PLANNING & ZONING AGENDA ITEM #9

SUBJECT: Approval of a Site Plan for Timberline Middle School

RE: Timberline School – Site Plan/Preliminary Plat & Final Plat

Per your request, staff has reviewed the proposed site plan/preliminary plat and final plat for the Timberline School. The property is generally located between SE Westtown Parkway and SE Ashworth Road along SE L.A. Grant Parkway, directly south of the Stone Prairie subdivision. Based upon our review, staff has the following comments related to the site plan/preliminary plat and final plat:

DRAWING NO.: C-301

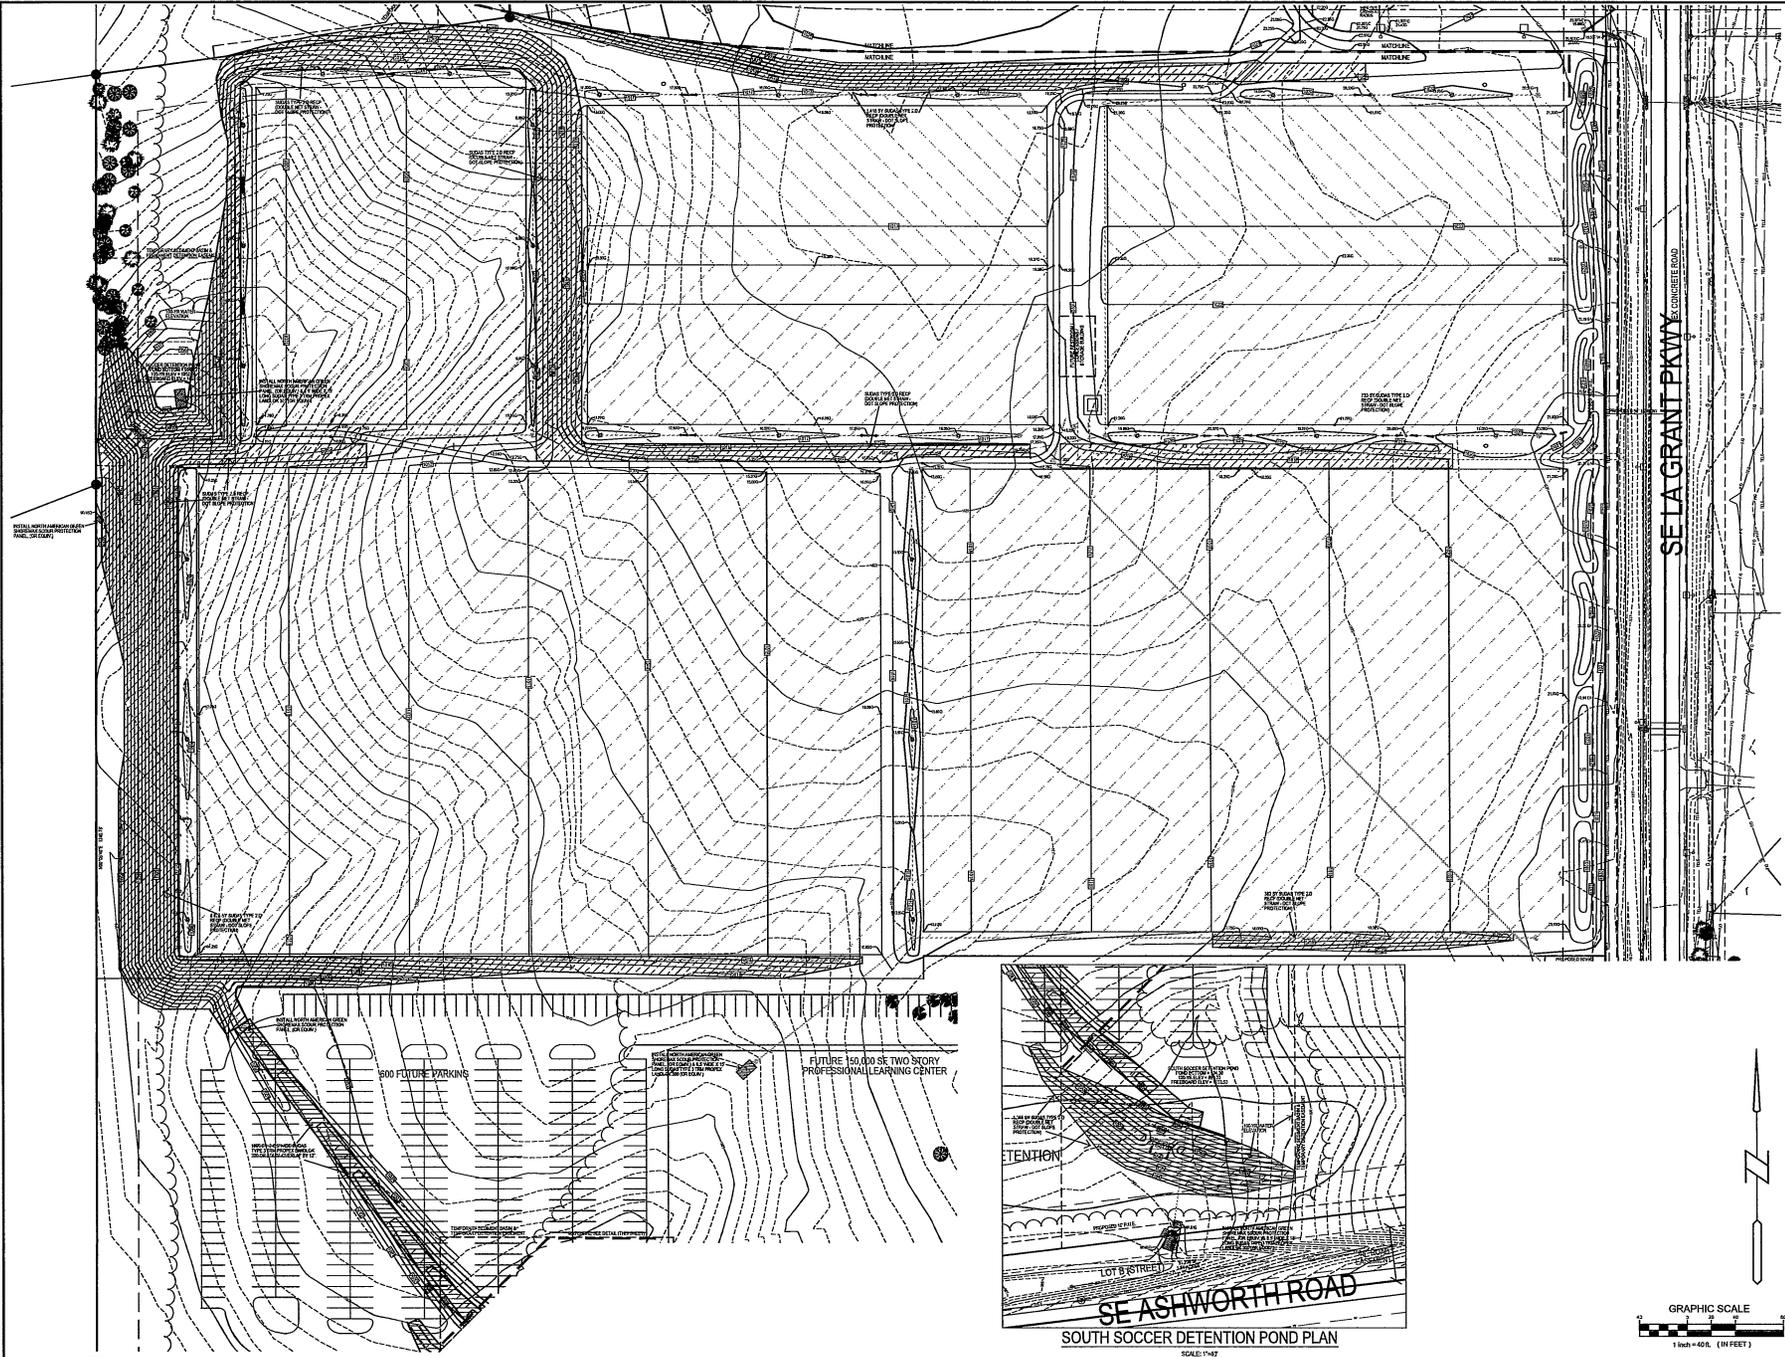
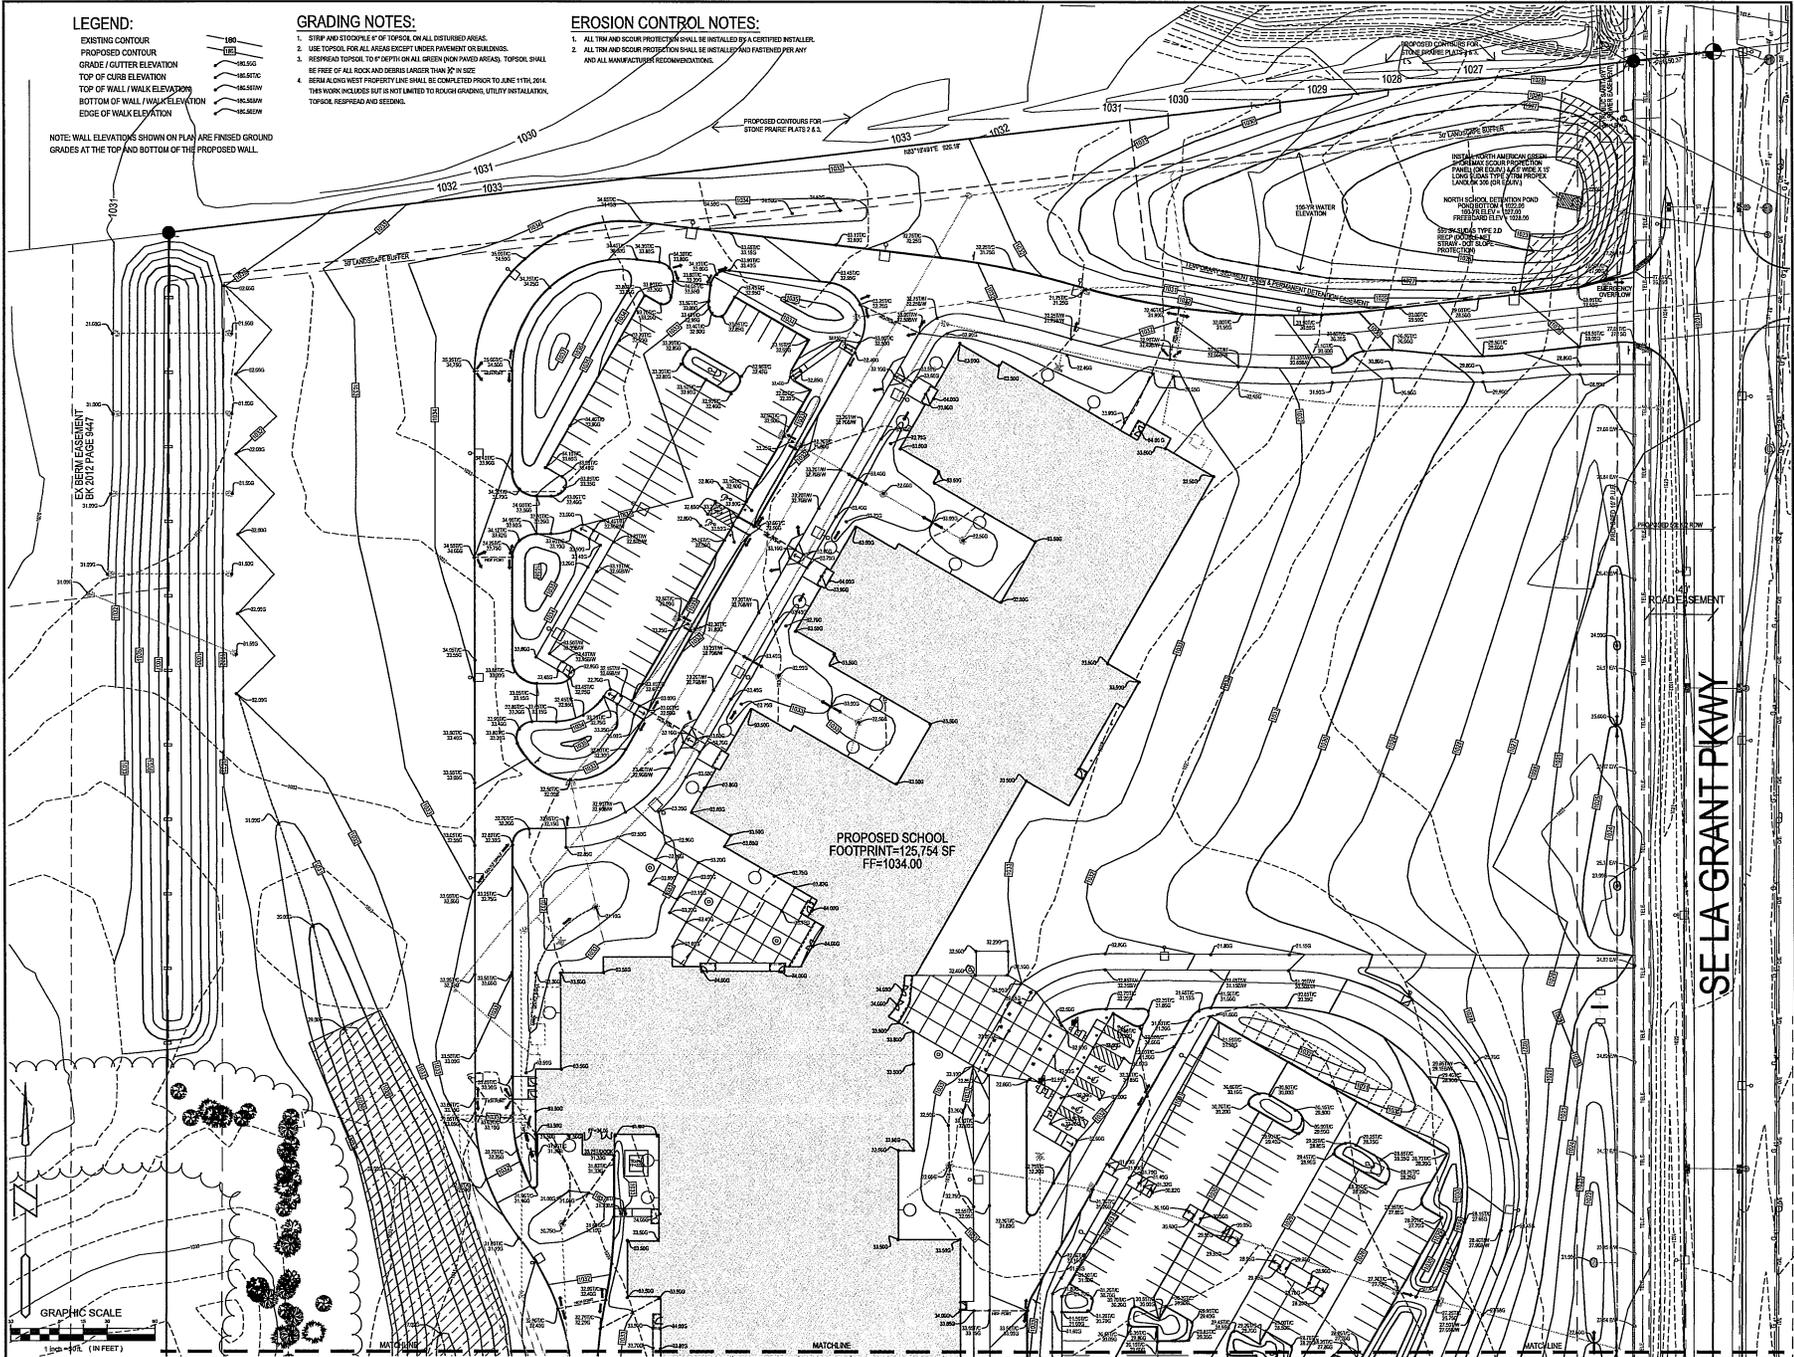
40. The legend should be updated to identify the "E/W" symbol used for the spot elevations indicated adjacent to the 10 foot public trail along SE L.A. Grant Parkway.

41. Berming should be provided adjacent to the parking stalls facing SE L.A. Grant Parkway. Berming should be provided at a minimum of a 3 foot tall berm at a 3:1 slope.

42. **The overflow path of all detention facilities and sump locations should be indicated on the plan set.**
43. A note should be added specific to the call outs for scour stop mat to be installed by a certified installer.

44. The grade elevations for the truncated domes related to the 10 foot public trail near the south entrance into the site from SE L.A. Grant Parkway should be indicated on the plan set.

45. **The grading plan should be revised to include spot elevations at all lot pins and spot elevations for all areas where a proposed swale or outlet extends from this site onto an adjacent site. Spot elevations related to swales or outlets onto adjacent property should**

be provided to verify that a 2% fall is being provided from this site across the adjacent site(s).

46. **Verify that the grade tie-ins on the north side of the site with the proposed grades identified as a part of Stone Prairie Plat 2 (previously provided) are accurate.**
47. **Off-site easements related to grading, storm sewer, and overland flowage should be identified on the grading plan.**
48. **Scour stop mat should be provided for the outlet near the western portion of the soccer complex outletting onto the Timberline Campground property (Structure #217A).**

DRAWING NO.:
C-401

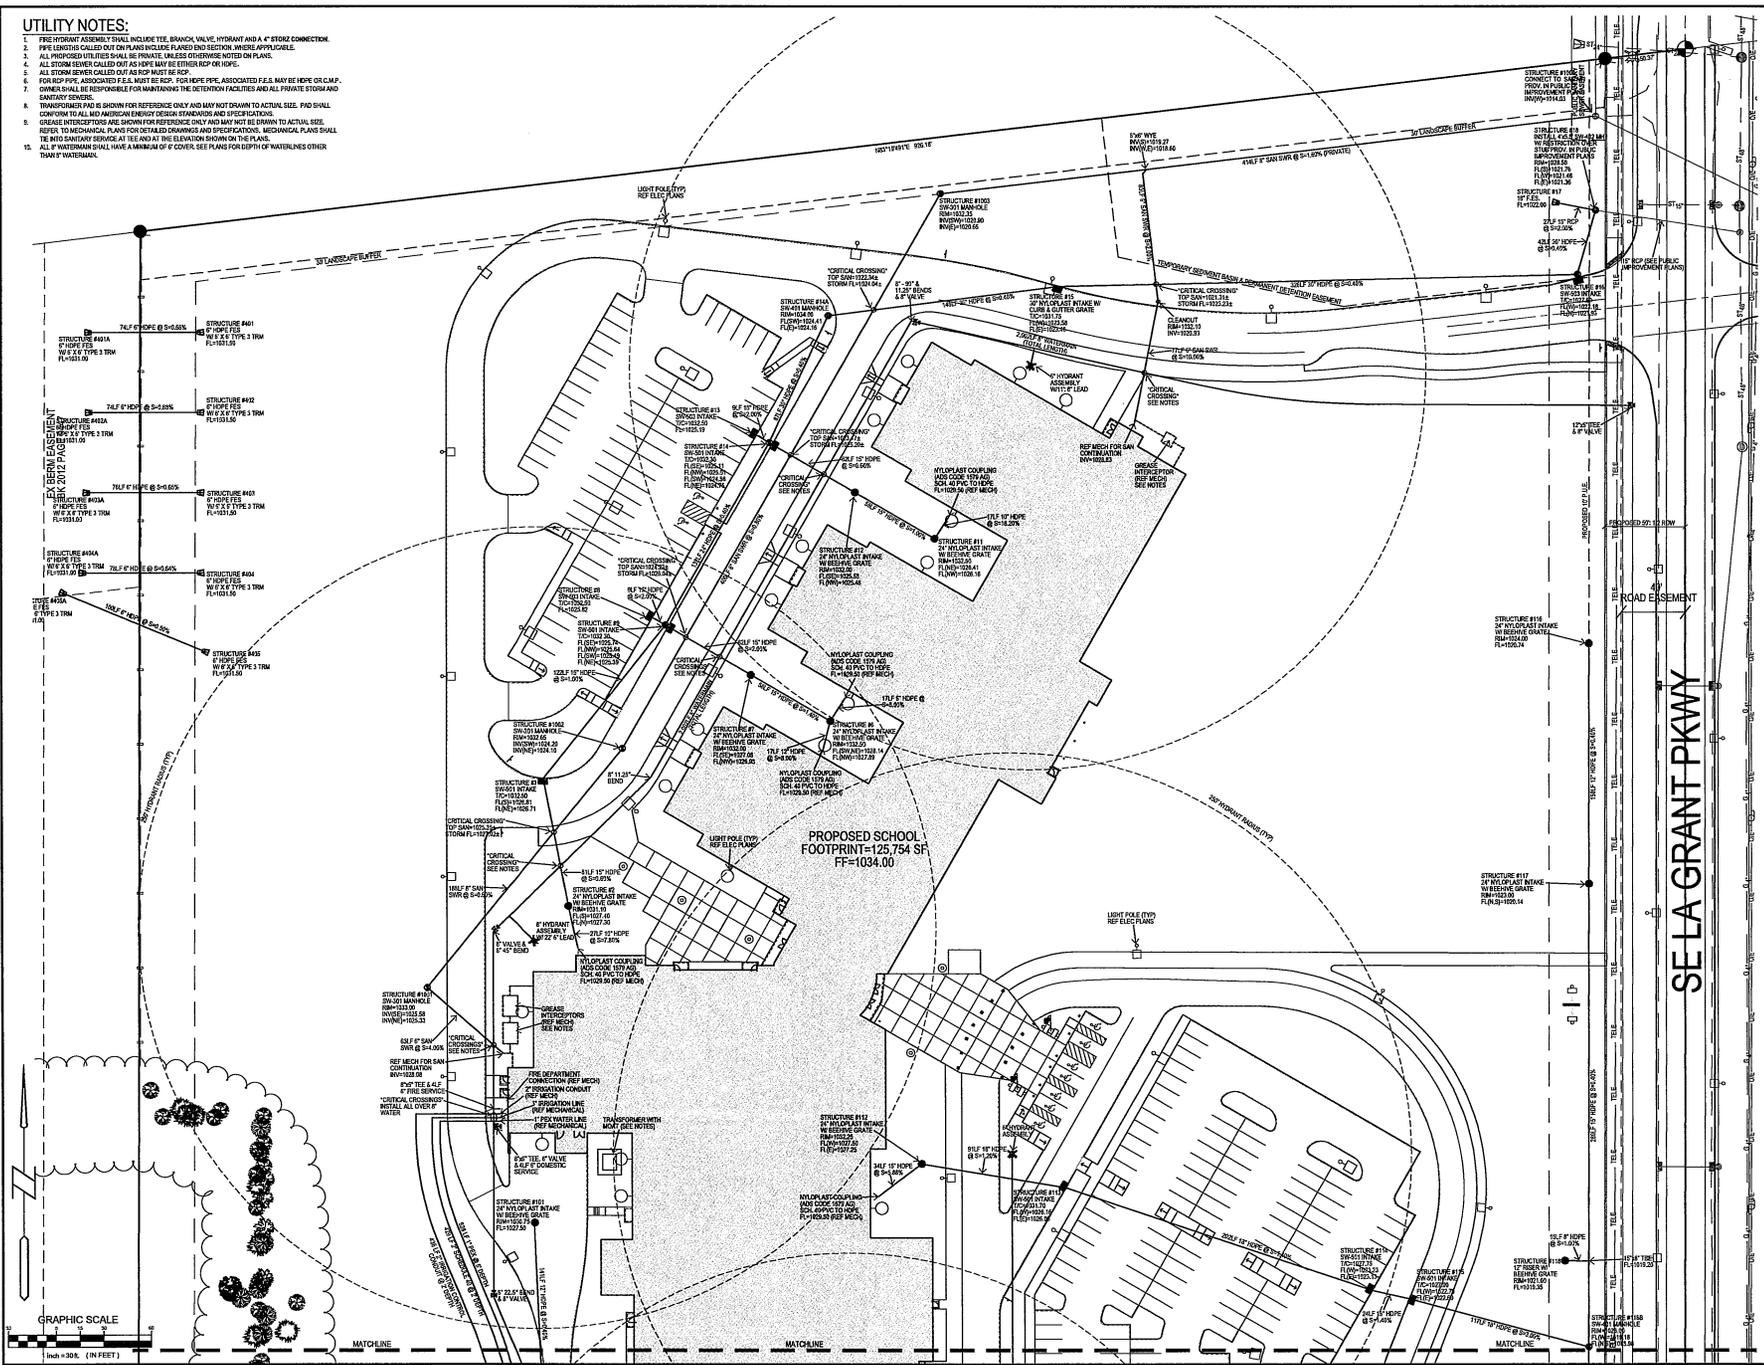
57. **A detail should be provided as a part of this plan set identifying the designed connection between roof drain and storm sewer.** ~~Additionally, a note should be provided on the site plan identifying the location of the detail within the plan set.~~

61. **Staff questions the proposed 6 inch sanitary sewer on the west side of the school near the grease trap interceptor as to whether these segments should also be 8 inch sewer to provide for adequate fall. Please address.**

PROJECT NO.: 1018K
 DATE: APRIL 2013
 REVISIONS:
 1. 04/15/13: BY CIVIL, ELECTRICAL, MECHANICAL, PLUMBING, AND CITY ENGINEER.
 DRAWING TITLE: LANDSCAPE PLAN
 DRAWING NO.: L-101

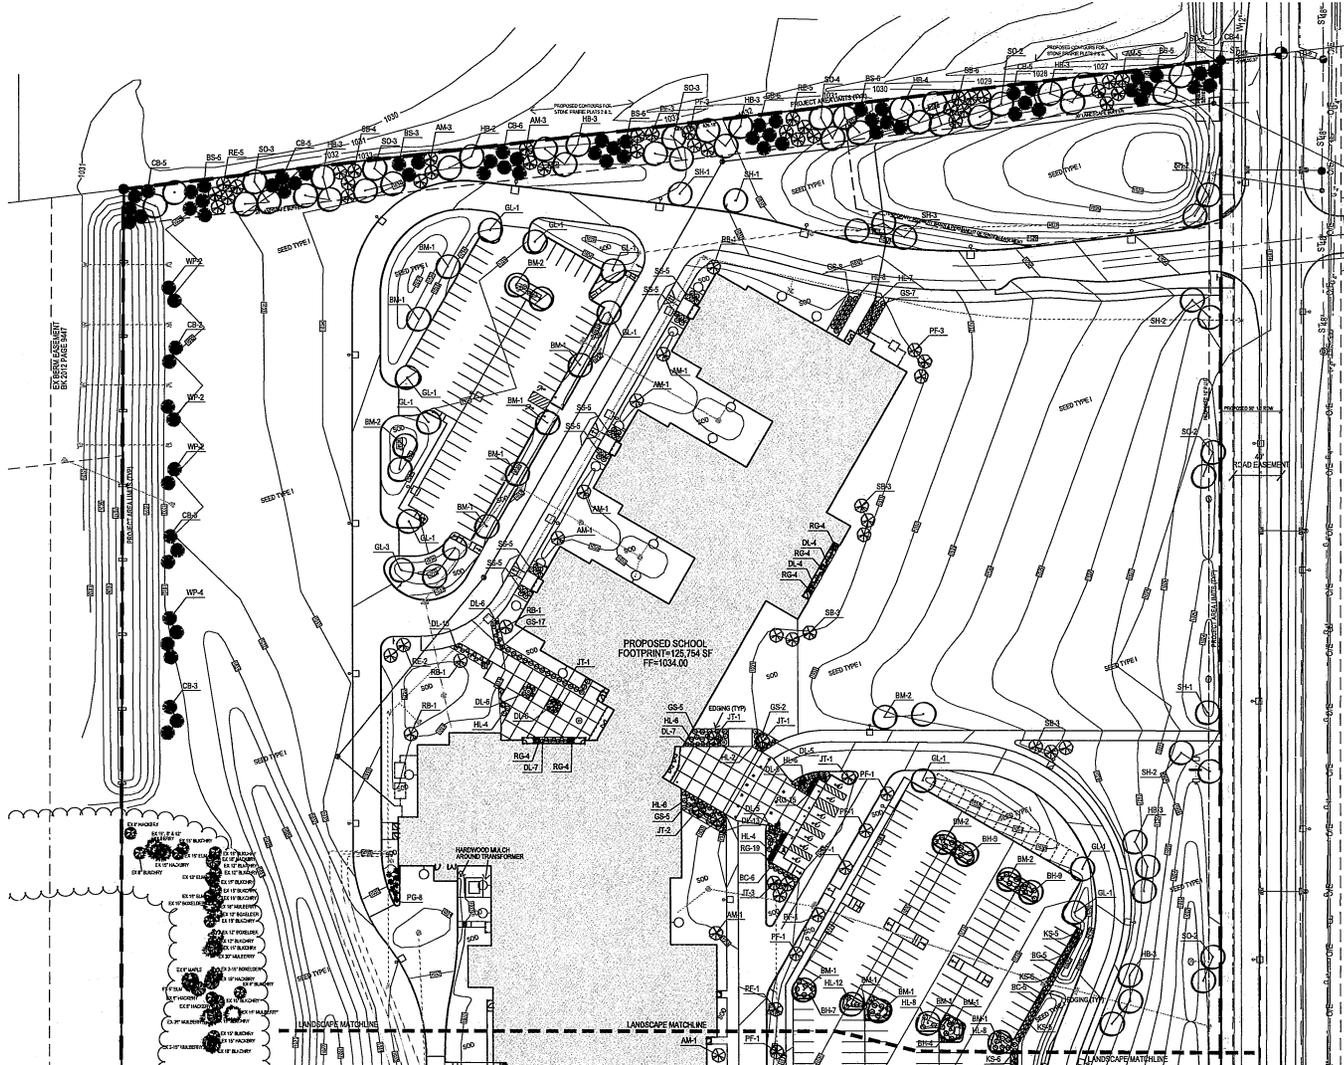
64. ~~A 30-foot landscape buffer should be provided along the northern property line to satisfy the ordinance requirement for buffering the transition of uses between R-2 Residential and Commercial. Additionally, the plantings within the buffer should be provided at a rate of 2 overstory, 3 evergreen, and 2 ornamental trees per 50 lineal feet of buffer.~~
